STATE OF VERMONT AGENCY OF TRANSPORTATION

PROPOSED IMPROVEMENT BRIDGE PROJECT TOWN OF HARTLAND COUNTY OF WINDSOR

RECORD PLANS	
CONTRACTOR:	KUBRICKY CONSTRUCTION CORP. - WILTON, NY
RESIDENT ENGINEER:	DARYL BASSETT
CONSTRUCTION BEGAN:	JUNE 10, 2014
CONSTRUCTION COMPLETE:	NOVEMBER 5, 2014
RECORD PLANS BY:	DARYL BASSETT & KEVIN KING
I HEREBY CERTIFY THAT ALL THE CONSTRUCTION REQUIRED BY THIS SET OF DRAWINGS HAS BEEN ACCOMPLISHED AS INDICATED HEREIN.	
BY	RESIDENT ENGINEER
DATE	2/22/16
NOTE: Any further information concerning final quantities, amounts or other details relative to this project may be found by contacting Vtrans Records Management.

US ROUTE 5 (MAJOR COLLECTOR), BRIDGE NUMBERS 62A AND 66

PROJECT NAME: HARTLAND	PLOT DATE: 3/3/2014
PROJECT NUMBER: BHF BPNT (12)	DRAWN BY: A.J. GOUDREAU
FILE NAME: zllc260deck.dgn	CHECKED BY: E.A. FIALA
PROJECT LEADER: M.A. COLGAN	SHEET 24 OF 55
DESIGNED BY: A.J. GOUDREAU	
BR 62A DECK REINFORCING

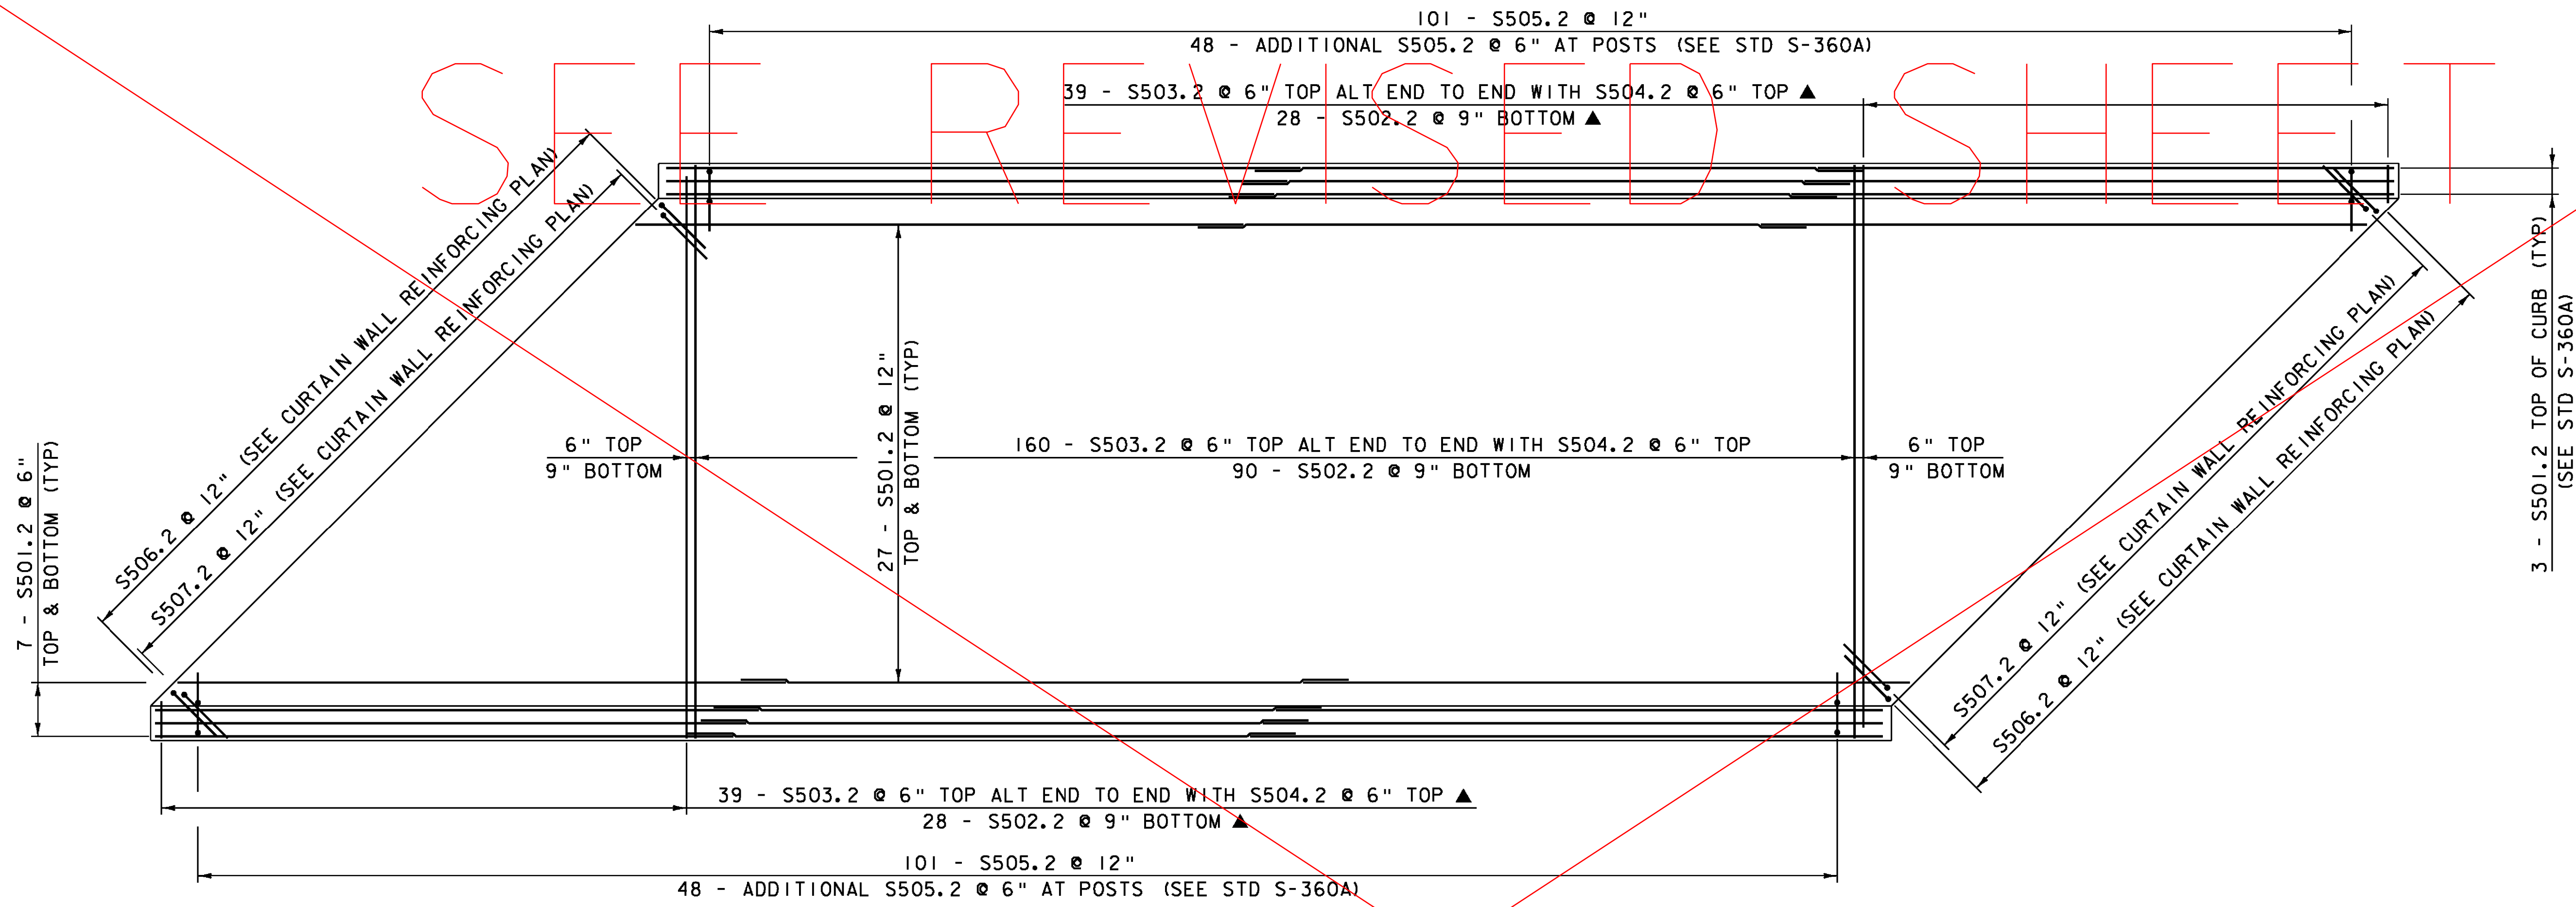
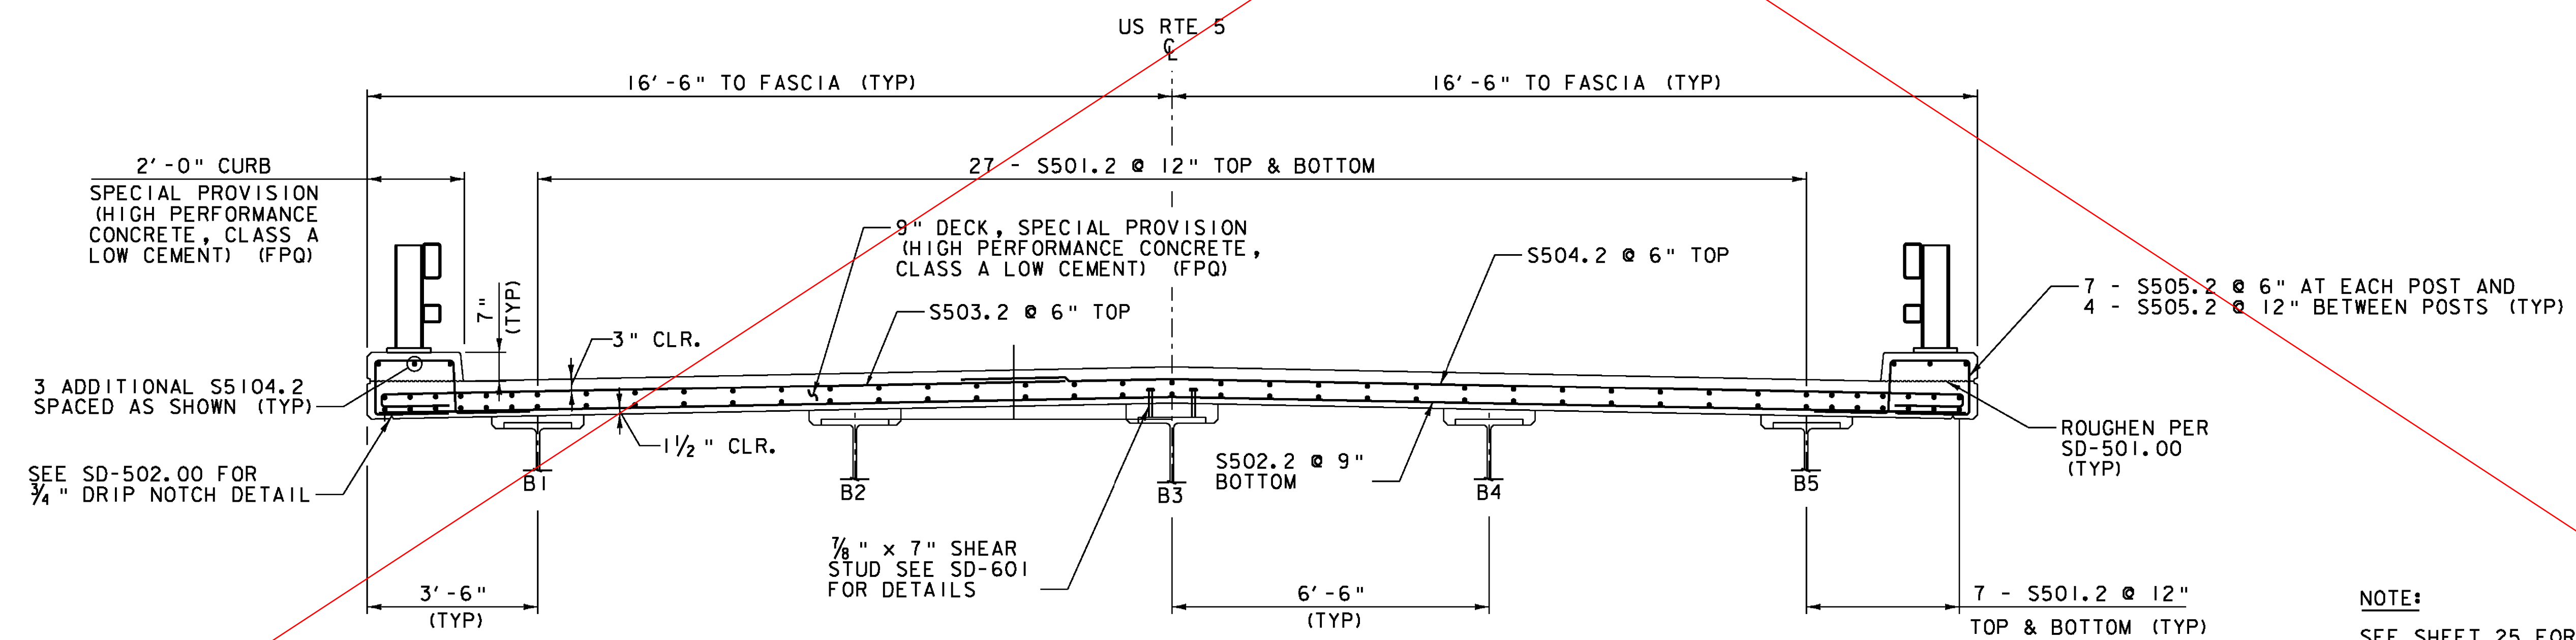
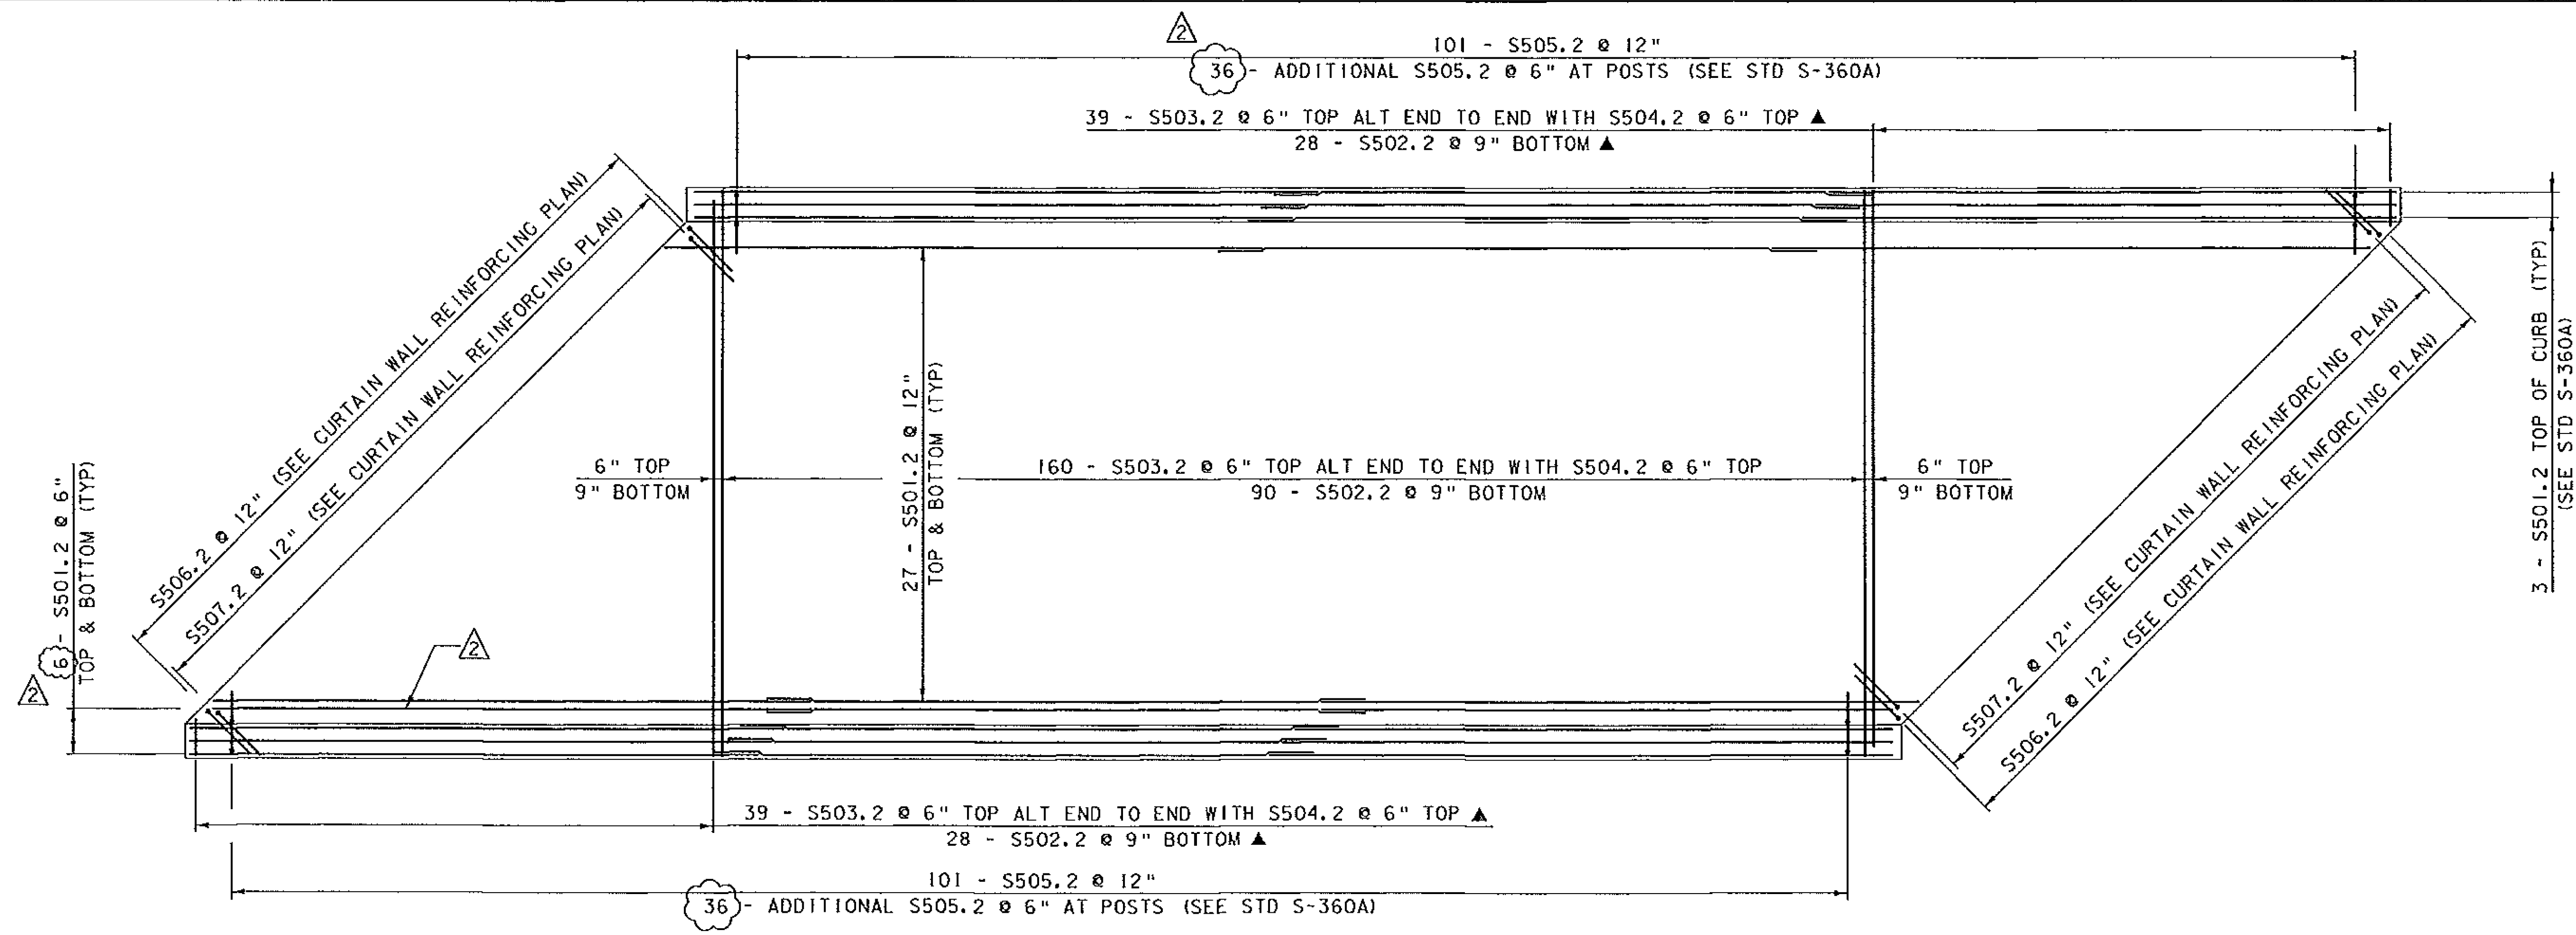
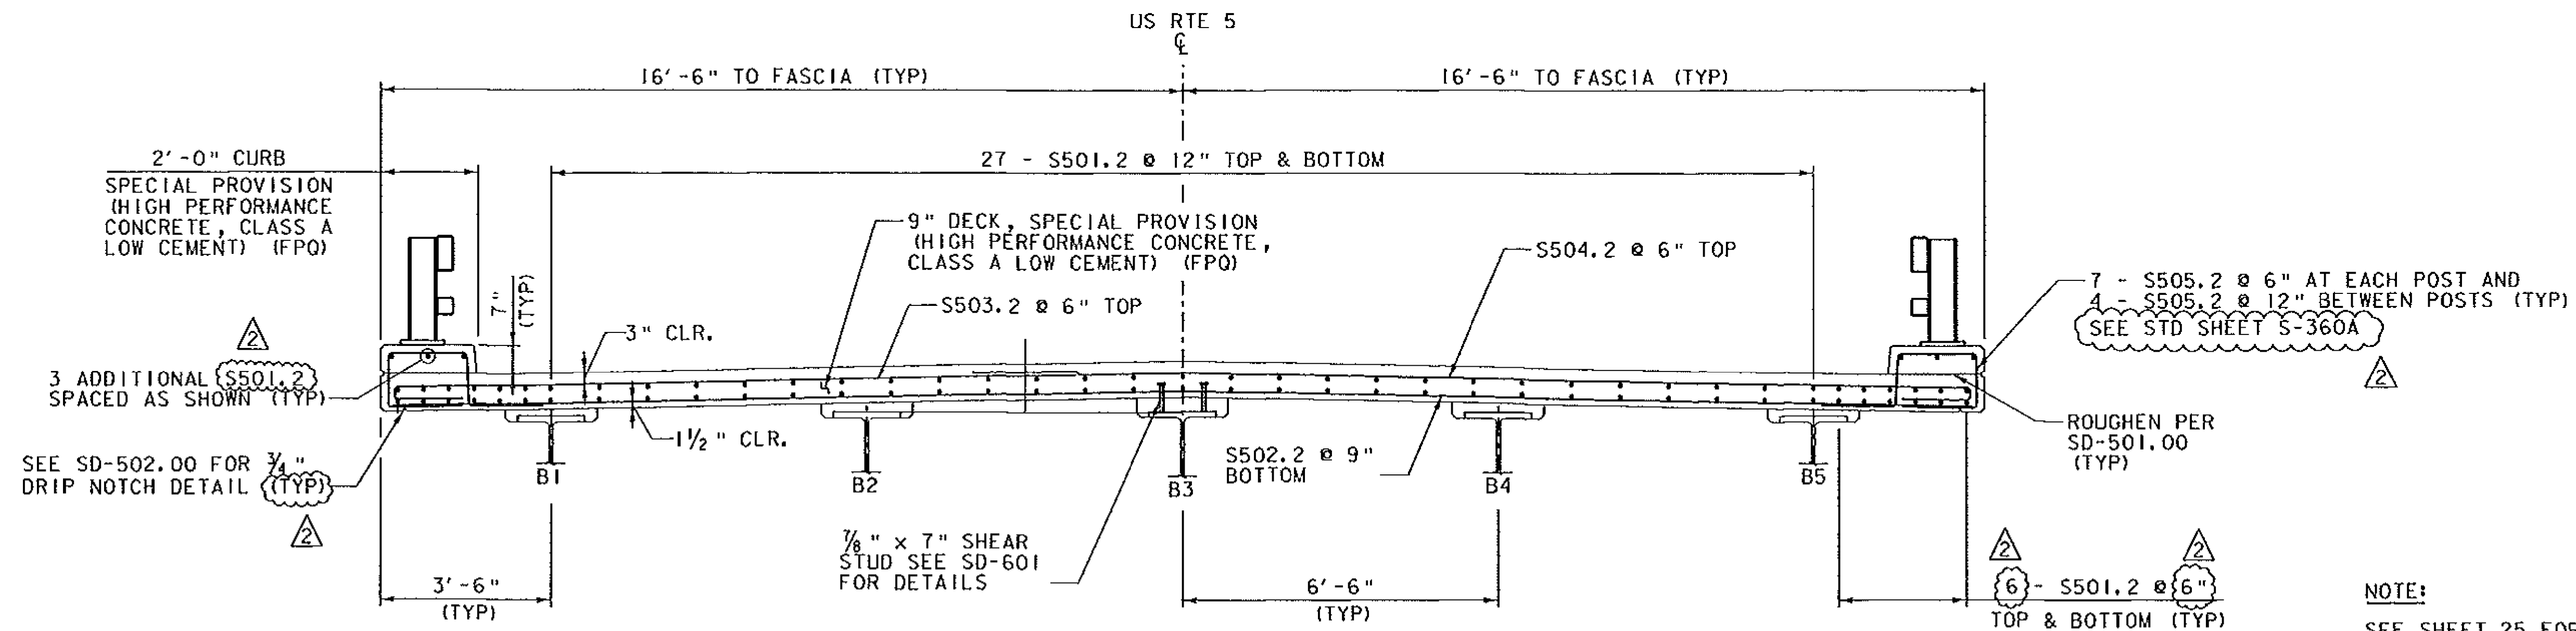
SEE REVISION SHEET
